Technical Bulletin B9512G / B8512G Authority Level Names incorrect

Issue severity	Products affected
High. Act immediately	 RPS / RPS-LITE v6.00, v6.01, v6.02 B9512G, B8512G control panels
Medium. Bosch Security Systems strongly recommends you take the action described below.	
Low. Advisory	
March 2, 2016

Figure 2: Authority Level Name parameters, RPS v6.02

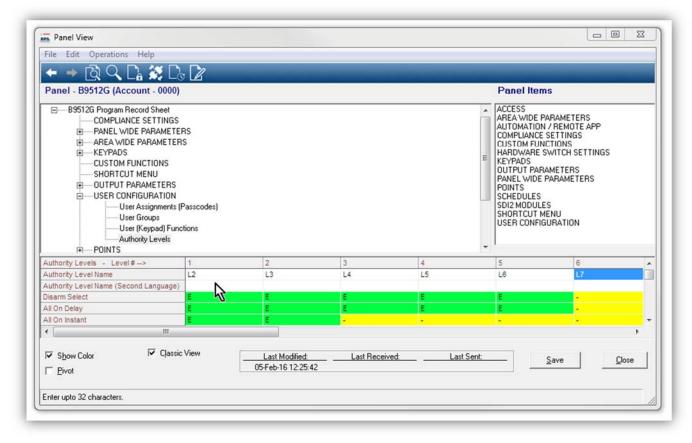
Issue 2: With RPS v6.01 or v6.02, the Authority Level Name parameters are incorrect for B9512G or B8512G control panel accounts for control panels with firmware v3.00.

The text for Authority Level 2 is shifted to Authority Level 1, the text for level 3 is shifted to level 2, and so on. The Authority Level Name for Authority Level 15 is blank.

The shift of Authority Level Names also occurs for B9512G or B8512G control panel accounts with firmware version 3.01 updated from firmware version 3.00.

There is no resolution for this Authority Level Name issue at this time.

Do not update control panel firmware from v3.00 to v3.01. Update from v3.00 to v3.02.

Important! When you update panel firmware from v3.00 to v3.02 be sure to receive the panel data from the control panel when you reconnect with RPS. Save the received panel data before you disconnect.

The workaround for the issue is:

- 1. Update RPS to v6.02.
- For control panel accounts with firmware v3.00, update the control panel firmware to v3.02 and then receive and save the panel data from the control panel, - or -

manually correct the Authority Level Names.

3. For control panel accounts with firmware v3.01 that was updated from v3.00, manually correct the Authority Level Names.
